**September 6, 2016**  
**BOARD OF COUNTY COMMISSIONERS**  
**ORANGE COUNTY, FLORIDA**  
**Y16-795-RM / Addendum No. 4**  
**ORANGE COUNTY COURTHOUSE COMPLEX AIR HANDLING UNITS**  
**REPLACEMENTS**  
**Bid Opening Date: September 8, 2016**

**ORANGE COUNTY  
COURTHOUSE AHU REPLACEMENT**  
425 N. ORANGE AVE. FLORIDA 32801  
100045182

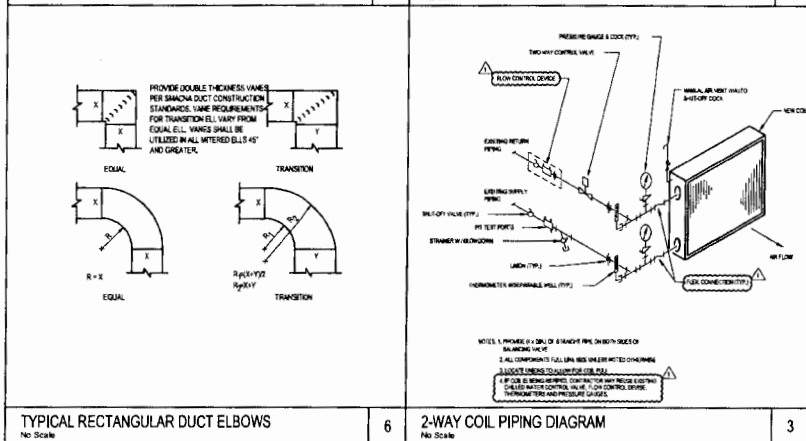
- A. The Bid Opening Date is remains September 8, 2016 at 2:00p.m.
- B. The Following are Drawings/Specification Changes:
1. Sheet M-301 HVAC Details; Detail 1 – Removed the words “Connect to existing duct”.

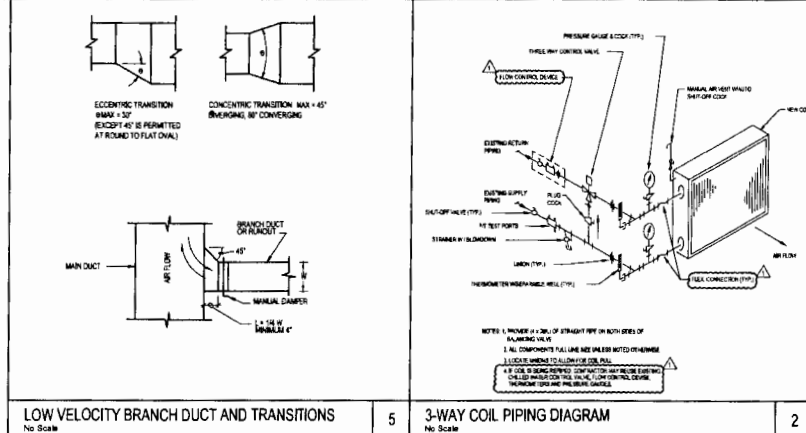
2. Sheet M-301 HVAC Details; Detail 2 – Renamed “Automatic Flow Control Device” to “Flow Control Device”. Removed the words “Connect to existing piping at flex connection (typ.)” and replaced with “Flex connection”. Added note 4 which reads “If coil is being repiped, contractor may reuse existing chilled water control valve, flow control device, thermometers and pressure gauges.”

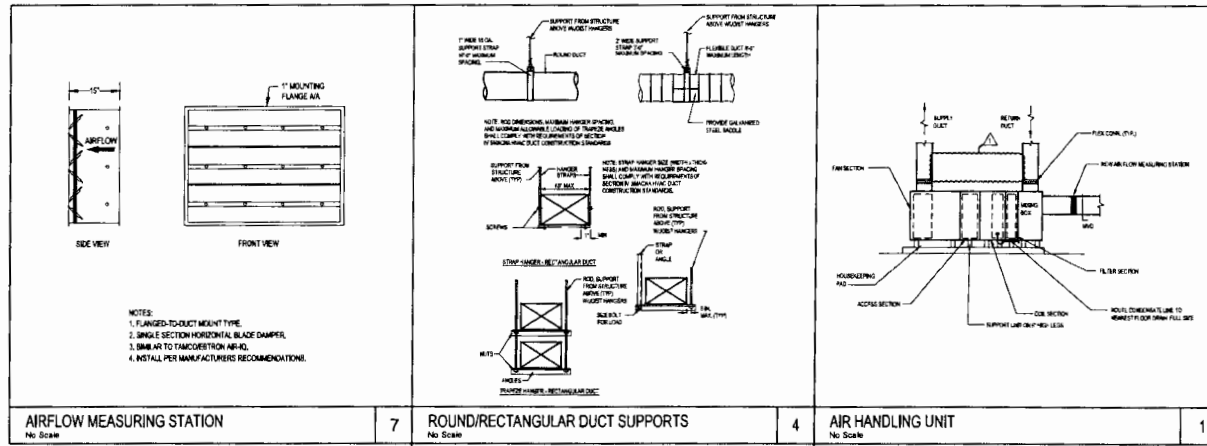
3. Sheet M-301 HVAC Details; Detail 3 – Renamed “Automatic Flow Control Device” to “Flow Control Device”. Removed the words “Connect to existing piping at flex connection (typ.)” and replaced with “Flex connection”. Added note 4 which reads “If coil is being repiped, contractor may reuse existing chilled water control valve, flow control device, thermometers and pressure gauges.”
